Application No. 10/552,884
Response dated September 26, 2006
OUTSTANDING OFFICE ACTION dated August 29, 2007

AMENDMENTS TO THE DRAWINGS

REMARKS / ARGUMENTS

Fig. 1

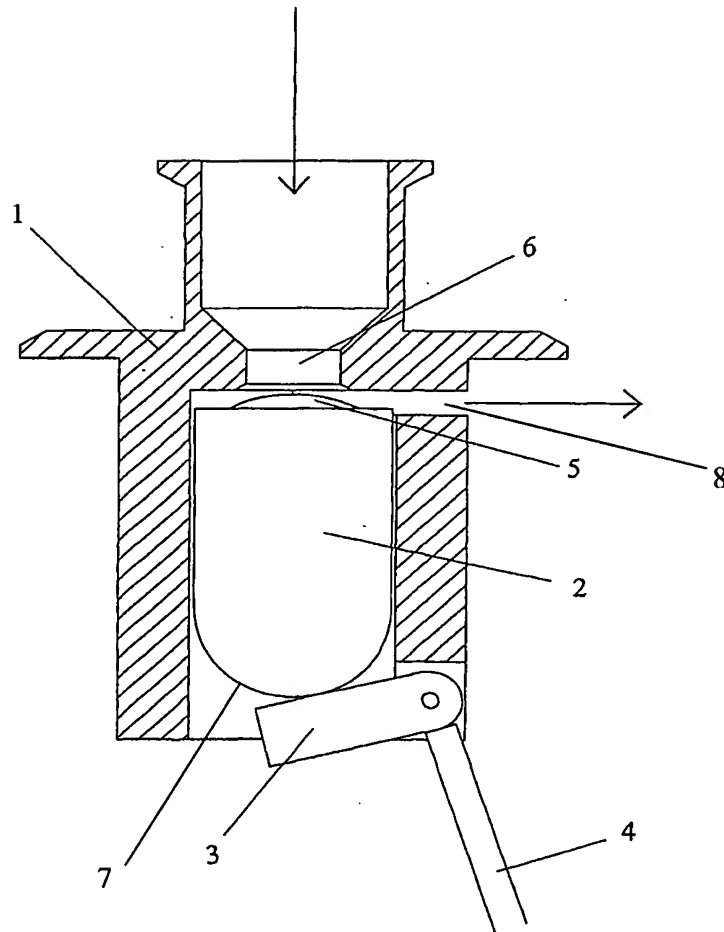
The attached drawing sheet includes changes to FIG. 1. This sheet, which includes FIG. 1, replaces the original sheet including FIG. 1. In FIG. 1, reference numbers have been added to more clearly define the present invention.

The drawing stands rejected under 37 CFR 1.83(a). In response to the Examiner's rejections, reference to the "float" and "bayonet flange" have been removed from the claims and the "front surface" has been labeled as item "7" in FIG. 1. It is respectfully submitted that the drawings are now in compliance.
